# HAMILTON MUNICIPAL HERITAGE COMMITTEE ADDENDUM

**Heritage Permit Application HP2018-046, Under Part V of the Ontario Heritage Act, for the erection of a single detached dwelling at 47 Markland Street, Hamilton (PED19035) (Ward 2)**

*Venetian-style window located above the side entrance on the west elevation of 45 Markland Street. Left: Inside view, Right: Outside view*

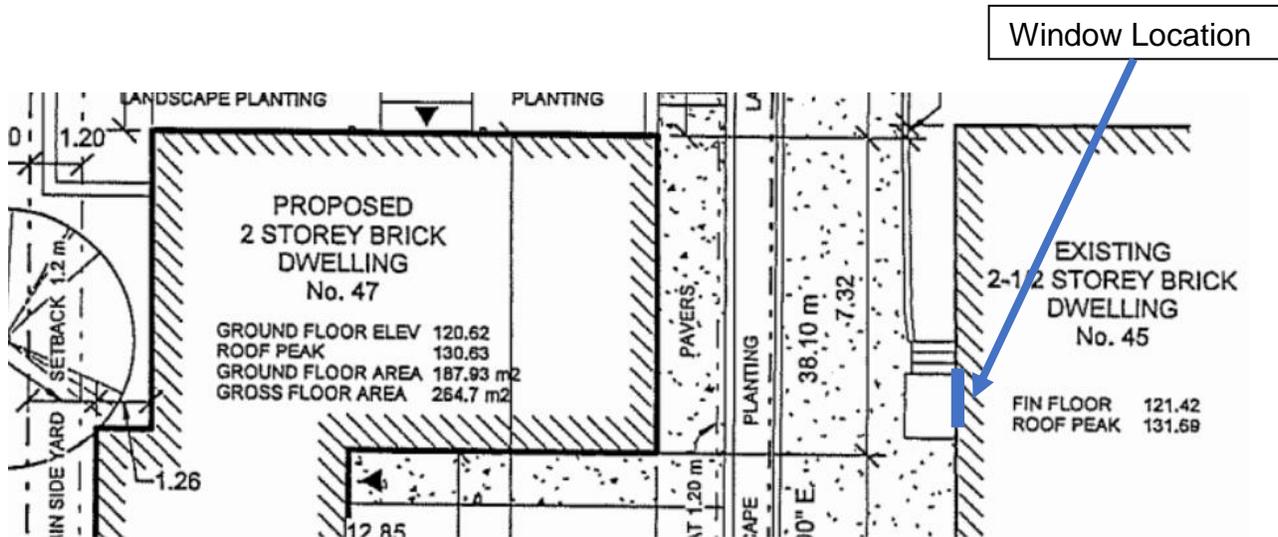
Siting and design of the proposed two storey portion of the structure blocks the western centre hall window at 45 Markland Street. This is a major (5.5 ft. x 7 ft.) westerly facing window providing important light to the upper and lower floors of 45 Markland street.

Further, the Durand-Markland Heritage Conservation District Study: Heritage Assessment Report specifically highlights the window in its assessment of 45 Markland Street describing it as the, “Venetian-style window located above the side entrance on the west elevation.”

This window is a primary and significant feature of the entire western elevation of 45 Markland, is of cultural heritage value, and thus its integrity should be accommodated in design and siting of a new adjacent infill.

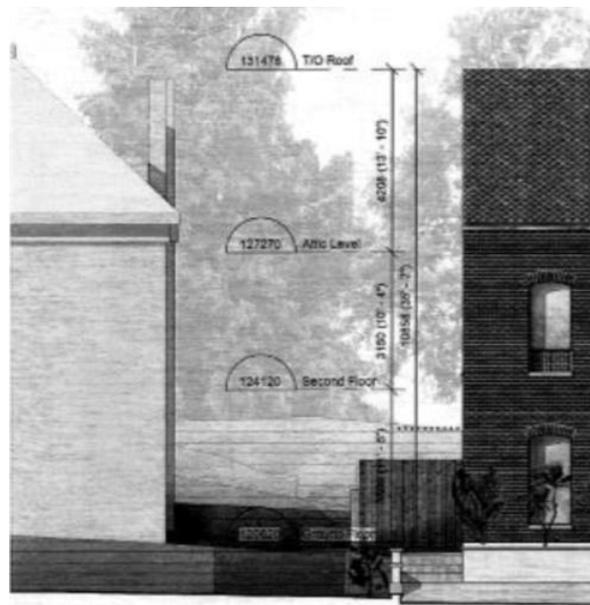
The current design has the two-storey portion of the proposed dwelling aligned as to block the full width of the window (see below). Additionally, the siting effectively minimizes the potential width between the two structures which impacts views and natural light to the major centre hall window of 45 Markland Street.

The eastern elevation of the proposed structure shows a roof design that extends vertically to the tallest peak (side gable), and does not slant like the north and south elevations (hip roof), similar to most neighbouring structures on the street, including 45 Markland Street. The major centre hall window on the western elevation of 45 Markland Street is the primary design feature and is of cultural heritage value. The current siting and design directly impact this cultural heritage feature of 45 Markland Street and therefore, siting of the structure and design of the roof should take specific steps to accommodate this.

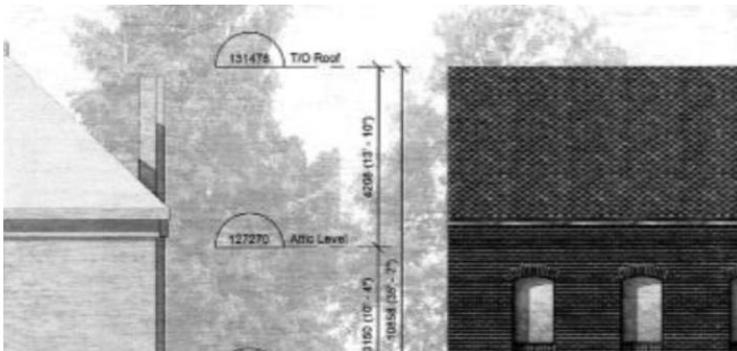
If a roof design was incorporated that was similar to adjacent houses whereby the east and west elevations slant away from their neighbours instead of extending vertically to the peak, the impacts on the western elevation of 45 Markland Street would be lessened (see illustrations below).

- a. *An assessment be conducted on the impact of the proposed design of 47 Markland Street on the Venetian-style window located above the side entrance on the west elevation of 45 Markland Street (e.g. sun-shadow impact analysis).*
- b. *That staff report back on measures that could lessen the impact (e.g. roof design).*
- c. *That final design of 47 Markland Street be approved after demonstrating that measures have been taken to lessen the impact, and maintain the integrity, of this important cultural heritage feature.*
